UNITED STATES PATENT AND TRADEMARK OFFICE

APPLICATION NO.	FILING DATE	FIRST NAMED INVENTOR	ATTORNEY DOCKET NO.	CONFIRMATION NO.
10/564,226	05/31/2006	Franz Thoemmes	10191/4495	7534
26646	7590	04/17/2009		
KENYON & KENYON LLP ONE BROADWAY NEW YORK, NY 10004			EXAMINER BOECKMANN, JASON J	
			ART UNIT 3752	PAPER NUMBER
			MAIL DATE 04/17/2009	DELIVERY MODE PAPER

DETAILED ACTION

Examiners marked up figure 9

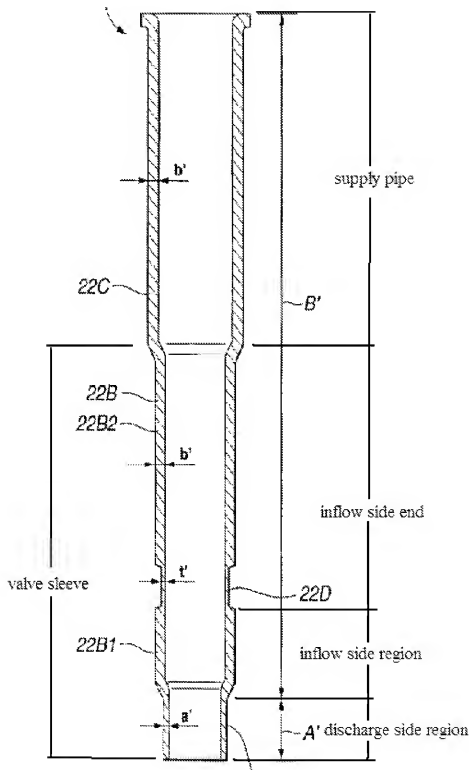
Kobayshi et al. shows a fuel injector (1) comprising; a valve needle (26) an armature (7C) forming an axially movable valve port together with the valve needle (7A), a restoring spring (9) acting upon the armature, a magnetic coil (11) cooperating with the armature, a valve-seat body (5), a valve closure member (7B) which forms a sealing seat with the valve seat body and; a valve sleeve (22) surrounding the armature and the

valve needle, a wall thickness of the valve sleeve varying across its axial direction (figure 9), wherein the wall the wall thickness of the valve sleeve decreases in a discharge direction of a fuel (figure 9), wherein an outer diameter and a radial cross section of the valve sleeve decrease between an inflow-side region and a discharge-side region on a color (figure 9), wherein the radial cross section and the wall thickness of the inflow-side region are constant from the collar to an inflow-side end of the valve sleeve (figure 9); wherein the decreased radial cross section and decreased wall thickness of the discharge-side region are constant form the collar to a discharge-side end of the valve sleeve (see examiners marked up figure below), and wherein the inflow side region of the valve sleeve is formed in one piece with a supply pipe (see examiners marked up figure 9 below).
